Jericho Imex Ltd (Extension Building)

DAG NO. 1726 & 856, MONTRIBARI ROAD, SOUTH SHALNA, SHALNA BAZAR, GAZIPUR-1703.
(24.031022, 90.390951)

17 October 2021

Lateral stability system

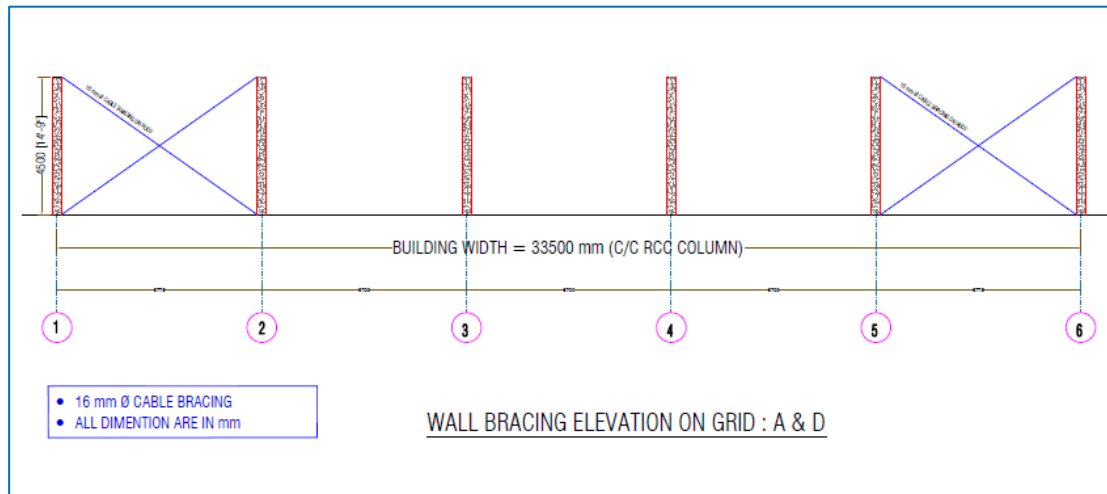
No compression strut/ lateral load transfer media at the roof level

No lateral load transfer media observed in roof. Also, bracing system has no compression member. As part of Engineering Assessment (EA) building engineer is required to check the stability system of the building and design the size & position of necessary compression element accordingly.

Item No.	Observation	Recommended Action Plan	Recommended Timeline
01	Apparently lack of lateral stability system (Shed-3).	As part of Engineering Assessment (EA) building engineer is required to check the stability system of the Building and design the size & position of necessary compression elements accordingly.	6-weeks
02	Apparently lack of lateral stability system (Shed-3).	Implement remedial actions where necessary.	6-months
03	Inconsistencies in as-built drawing (Shed-3).	The building engineer to survey the structure and prepare as-built structural drawings with connection details.	6-weeks
04	Design report required to be revised and submit to RSC (Shed-3).	Building Engineer to prepare design report as per BNBC (part-6; Article 1.9.1).	6-weeks

Inconsistencies in as-built drawing

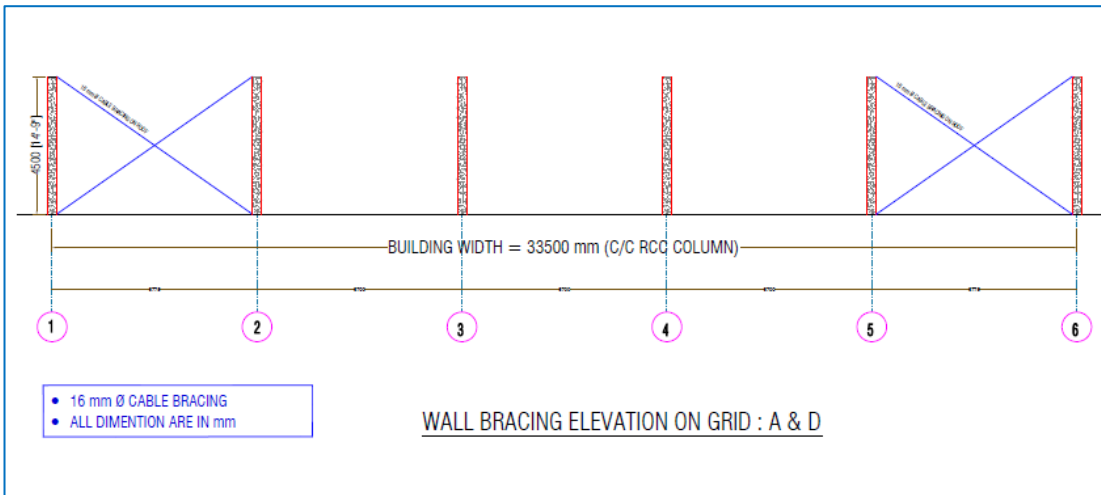
Vertical bracings on drawings which are not found onsite

No vertical Bracings on site

Details of RC tie beams were not found in provided drawings. Vertical cross-bracing and flange bracings were shown in drawings but onsite those are not found. Moreover, connection details of bracings were not found in drawings.

No flange bracing onsite

Vertical Bracings on drawings

Flange bracing on drawings

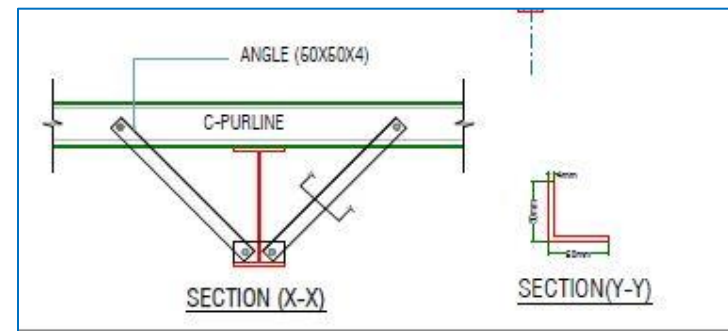
No vertical Bracings

**Design report required to be revised and
submit to RSC**

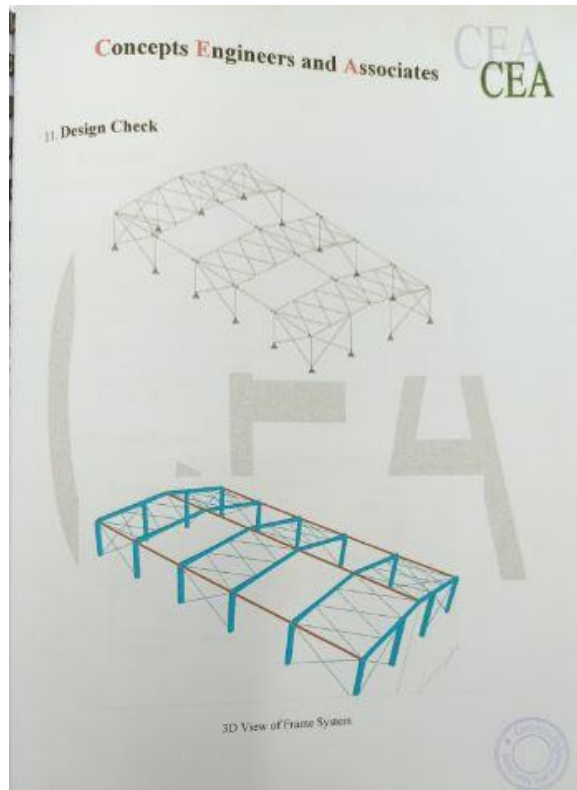
As per BNBC, every building or structure designed shall have its design documents prepared in accordance with the provision of Section 1.9.1. The design document shall include a design report, and a set of structural drawings, which shall be prepared in compliance with section 1.9.1.1 and section 1.9.1.2 of part-6, BNBC.

A Design Report with software-based analysis file was provided for Shed-3. Purlins are considered as compression strut, but adequacy check of the purlins are not provided in the design report. Tensile strength of MS plate 50 ksi has been considered in design report but no test report was found. Vertical bracings were not found on site whereas design report shows vertical bracings in both direction.

Item No.	Observation	Recommended Action Plan	Recommended Timeline
05	Design report required to be revised and submit to RSC (Shed-3).	The factory is required to carryout tensile test of MS plate from existing elements of the Shed-3 and fill the cutting space by same specification.	6-weeks
06	Design report required to be revised and submit to RSC (Shed-3).	Revise design report based on the result of MS plate test report.	6-weeks
07	Design report required to be revised and submit to RSC (Shed-3).	Implement the recommendation of design report.	6-months
08	Loose cable bracing (Shed-3)	The building engineer to check the bracing and tighten it properly.	6-weeks
